## Product Change Notice (PCN)

PCN Number: PCN-0462303R-01

Product(s) Affected: TB003V-500 Series. Inclusive of both screw types and colors.  
Screw types: Phillips and Slotted  
Colors: BE/Blue, GR/Green, OR/Orange, YL/Yellow, GY/Gray and BK/Black

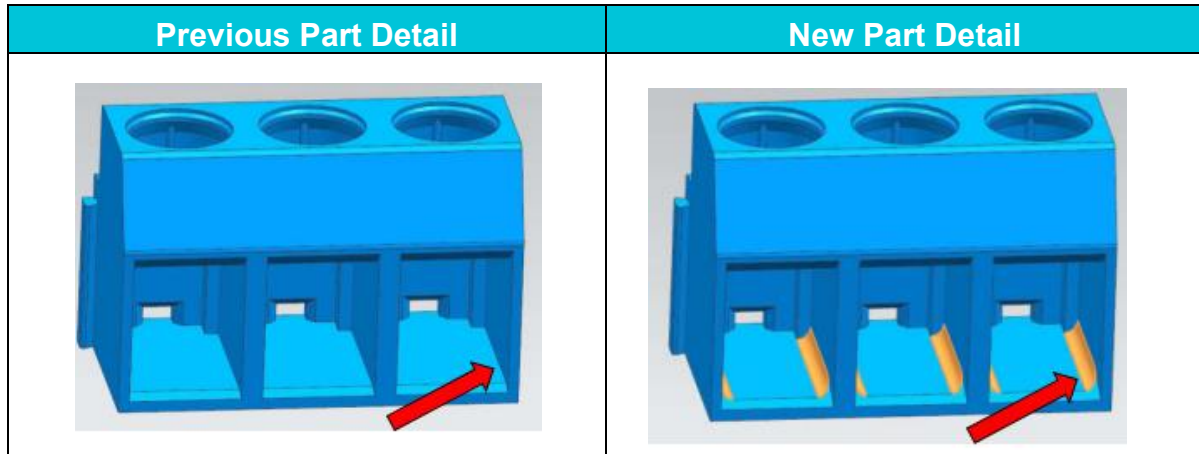
Reason(s) for Change: **Improve structural strength**

Description of Change: *Modified Housing. Add a 0.5mm thickness chamfer on the place which is right angle chamfer in the lower corners, as indicated in orange on the image below.*
